**SUBJECT: THREE MILE ISLAND, UNIT 1 (TMI UNIT 1)
OPERATING LICENSE No. DPR-50
DOCKET No. 50-289
LICENSE AMENDMENT REQUEST NO. 303 -
PRESSURE-TEMPERATURE PROTECTIVE LIMITS**

TMI Unit 1 License Amendment Request No. 303

Safety Evaluation and No Significant Hazards Consideration

Affected TMI Unit 1 Technical Specification Pages

Figure 2.1-1

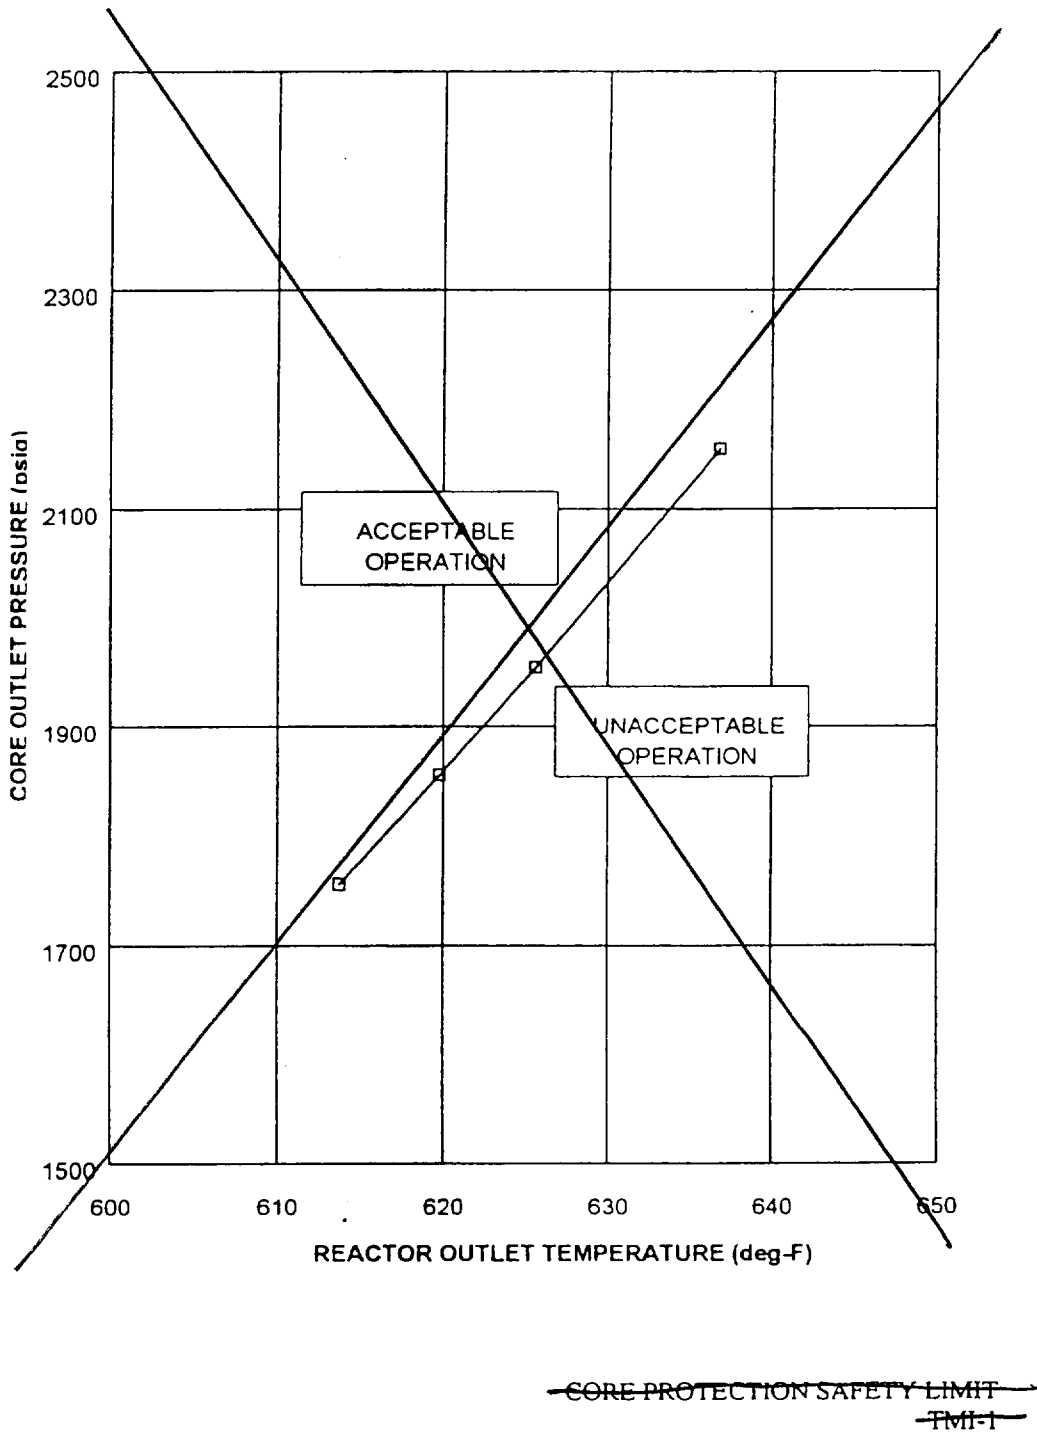
The proposed change relocates Technical Specification Figures 2.1-1, 2.1-3, and 2.3-1 to the TMI Unit 1 Core Operating Limits Report (COLR). The initial implementation of the COLR for TMI Unit 1 was approved by the NRC as Amendment No. 150, dated July 6, 1989. The TMI Unit 1 COLR is established and controlled in accordance with NRC Generic Letter 88-16, "Removal of Cycle-Specific Parameter Limits from Technical Specifications," dated October 4, 1988, which allowed licensees to remove cycle-specific parameters from Technical Specifications and place them in a COLR provided the limits are developed using NRC-approved methods. Changes planned for future TMI Unit 1 reload core designs (e.g., Mk-B12 fuel with fine mesh debris filters in Cycle 14 and implementation of Framatome Cogema Fuel's Statistical Core Design Methodology in Cycle 15) are expected to result in periodic revisions to the variable low reactor coolant system (RCS) pressure-temperature core protection safety limits. Therefore, AmerGen is requesting that the variable low RCS pressure-temperature core protection safety limits be considered cycle-specific parameters and relocated to the TMI Unit 1 COLR. TMI Unit 1 Technical Specification Section 6.9.5 provides existing controls for the COLR in accordance with GL 88-16.

2.1.1 The combination of the reactor system pressure and coolant temperature shall not exceed the safety limit as defined by the locus of points established in ~~Figure 2.1.1~~. If the actual pressure/temperature point is below and to the right of the line, the safety limit is exceeded.

DELETED

the Variable Low RCS Pressure - Temperature Core Protection Safety Limits as specified in the COLR.

FIGURE 2.1-3

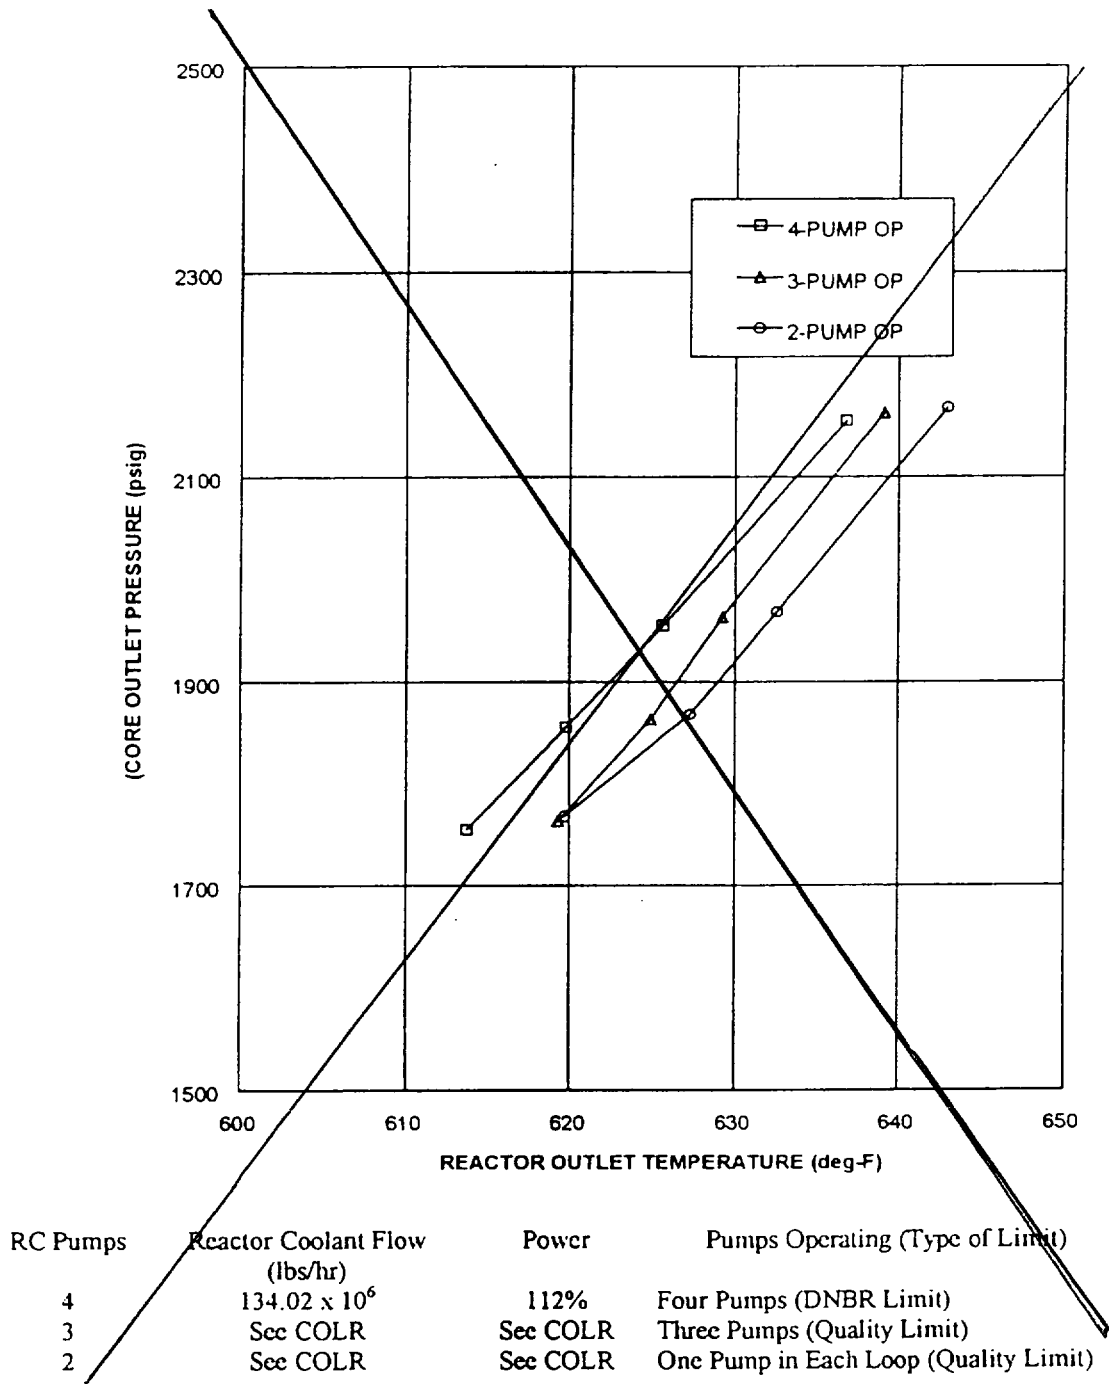
DELETED

~~CORE PROTECTION SAFETY BASES~~
~~TMI-1~~

Variable Low RCS Pressure-Temperature Core Protection Safety Limits in the COLR

Figure 2.3-1

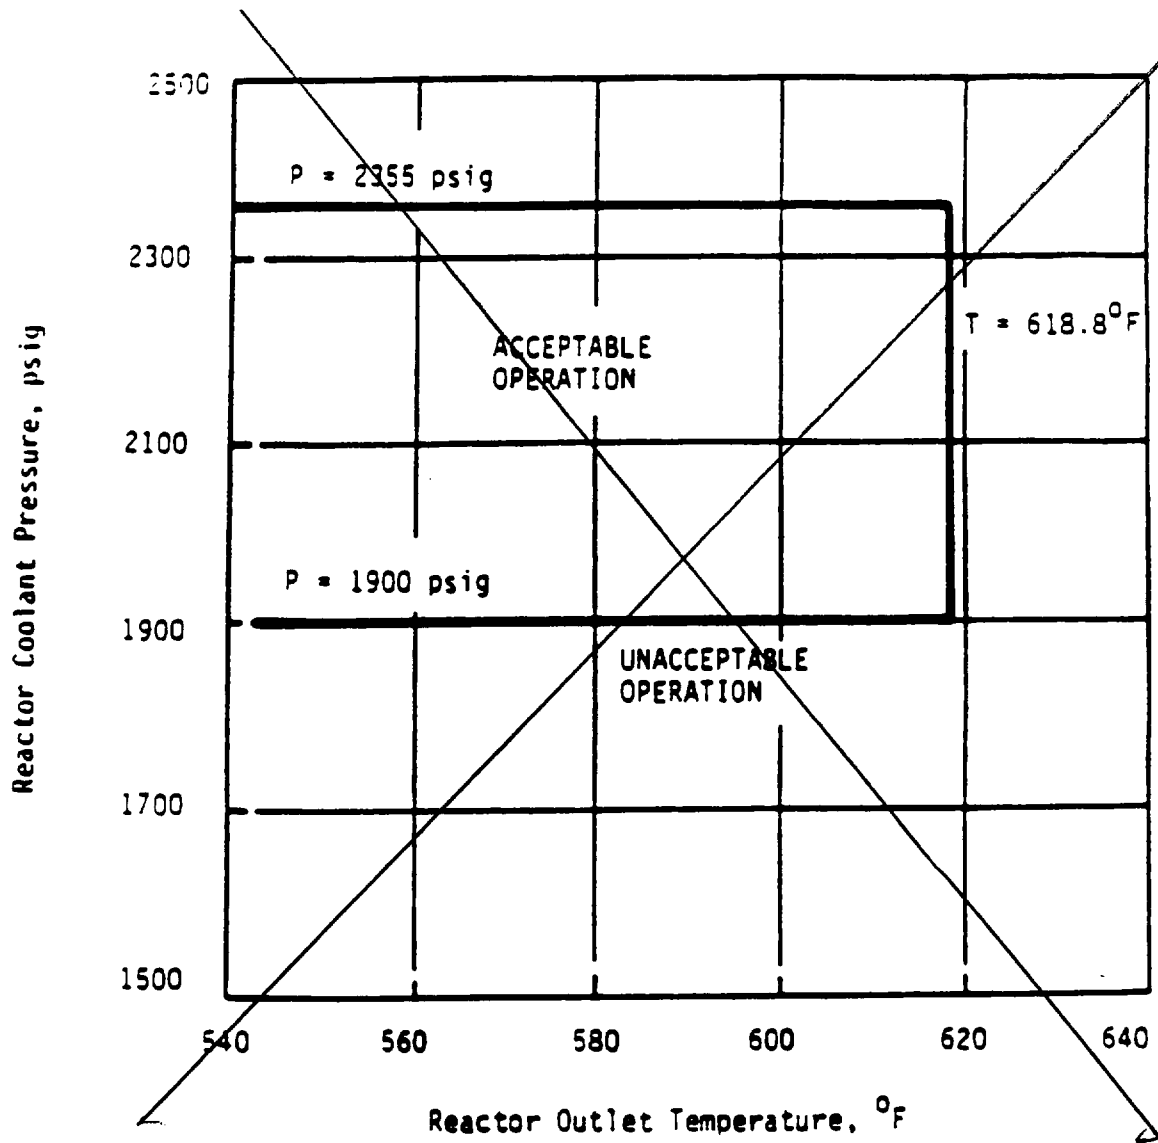
DELETED

~~TMI-1~~
~~PROTECTION SYSTEM MAXIMUM~~
~~ALLOWABLE SETPOINTS~~

Specified in RCS Pressure-Temperature Protective Maximum Allowable Setpoints Figure in COLR
